Response to Referee 1 Comments on:

Influence of building collapse on pluvial and fluvial flood inundation of metro stations in central Shanghai

Zhi Li, Hanqi Li, Zhibo Zhang, Chaomeng Dai, and Simin Jiang

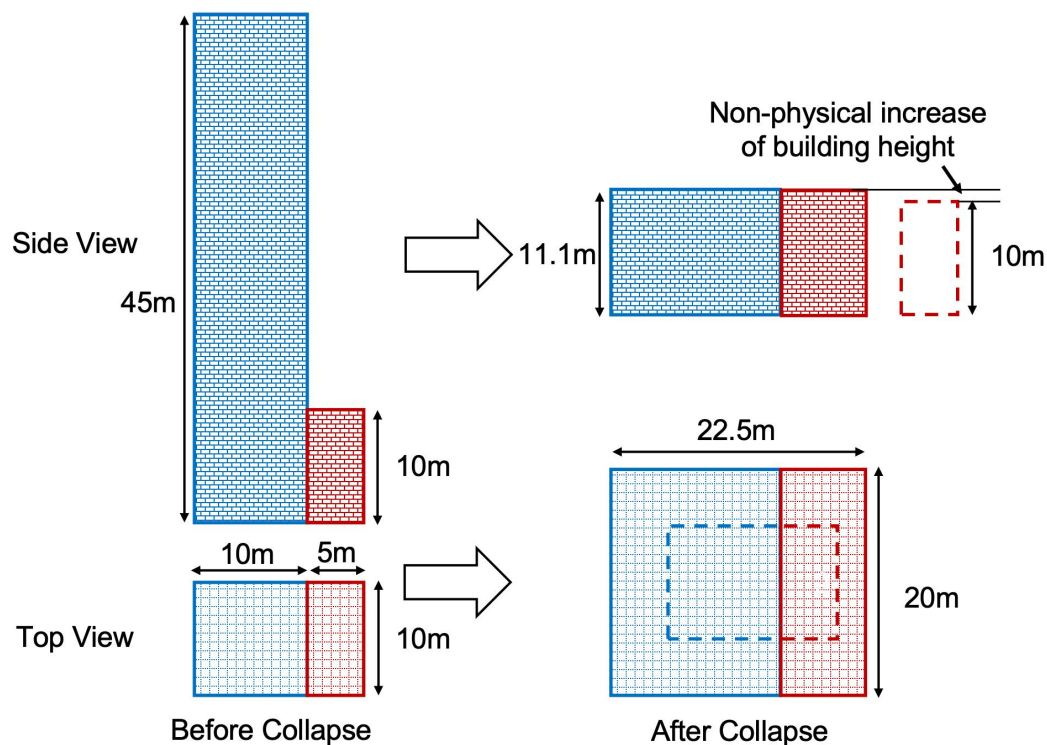
4. Line 140: Provide more information on the collapse mechanism. Although the model is cited, it would be helpful to provide a few more details on the adopted collapse mechanism. For instance, how is the presence of nearby buildings considered? How far do the debris reach?

Response: We have provided more detailed description of the building collapse mechanisms and the estimation method considered in our analysis, including the treatment of nearby buildings. We have added a new figure to assist the illustration:

“building collapse is modeled by distributing certain amount of the ‘‘building material’’ to its surroundings, thereby increasing the spatial occupancy and reducing the height of the building. In this study, we assume that when a building collapses, (i) its spatial occupancy doubles, and (ii) its total volume remains unchanged. The increased spatial occupancy (i.e., the ‘‘debris’’) is distributed uniformly around the building. The reduced height of the building can be estimated using the volume and the new spatial occupancy. A special case exists when two buildings are adjacent and their spatial occupancy overlap when collapsed. In such situations, the two buildings are treated as one single building when calculating the debris extent. It should be noted that if two buildings with different heights are treated as one building, the final building height after collapse could be greater than its original height, which is unrealistic (Fig.3). However, this phenomenon has negligible influence on the subsequent flood simulation because as long as the building debris is not inundated, slight variation of its height has minor influence on the flow field. That is, the

obstruction of the flow path (due to the spreading of the debris extent) has much stronger influence on flood propagation than minor changes of the debris height. With this approach, building collapse is only a simplified representation of the consequence of hypothetical seismic events, but the physical mechanism connecting earthquake and building collapse is not involved.
